TOSHIBA Microcontrollers TX03 Series

TMPM330FDFG TMPM330FYFG TMPM330FWFG

Restrictions on Consumer Electronics Control (CEC)

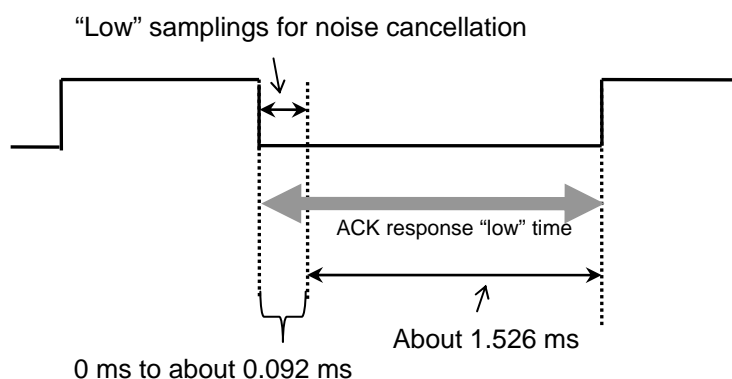
1. Set the same values to both “low” samplings for noise cancellation CECRCR1<CECLNC> and the rising timing of data bit CECTCR<CECDTRS>.
2. Set the values of “low” samplings for noise cancellation CECRCR1<CECLNC> between “000” and “011”.

2. "Low" output timing when a minimum cycle error occur

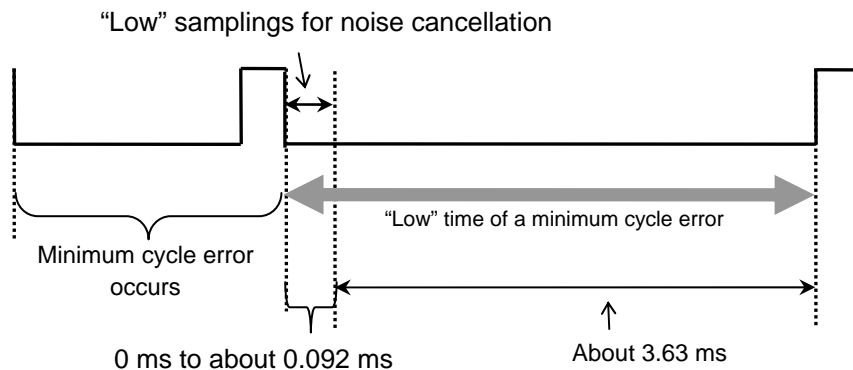
"Low" output timing when a minimum cycle error occurs is as shown below.

Minimum cycle error "Low" time = ("Low" samplings for noise cancellation) + (Base time: 3.63ms)

When a minimum cycle error occurs, "low" signal is output (about 3.63ms) after the elapse of "Low" samplings for noise cancellation.

- Corrections on the page of CECTCR (Transmit Control Register)

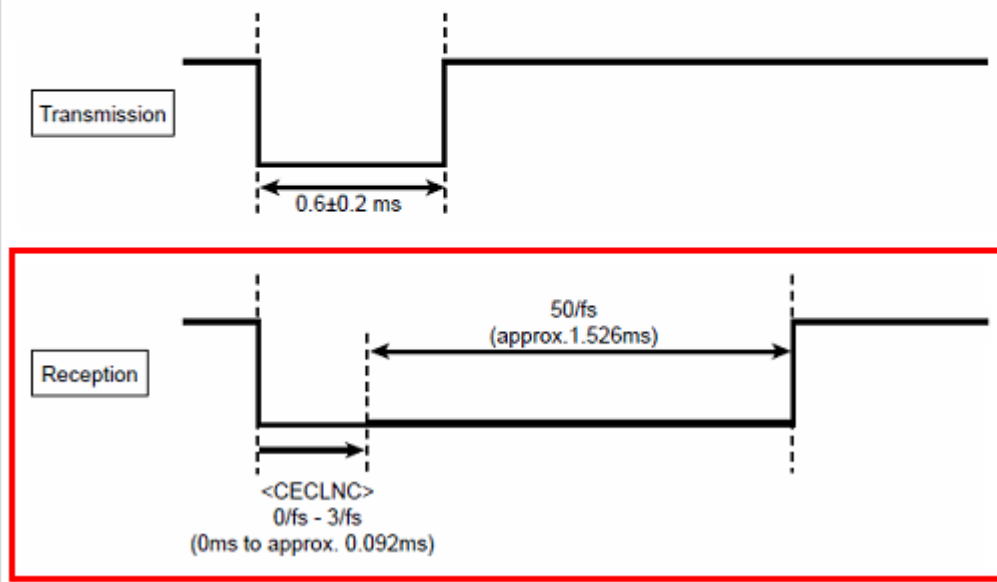
1. The following part has been deleted:

A setting example when rising timing of data bit<CECDTRS> is the base time $4/f_s$ or higher.

2. A note was added as follows: Use <CECDTRS> with the same settings with CECRCR1<CECLNC>.

Note: <CECDTRS> must be used under the same setting as CECRCR1<CECLNC>.
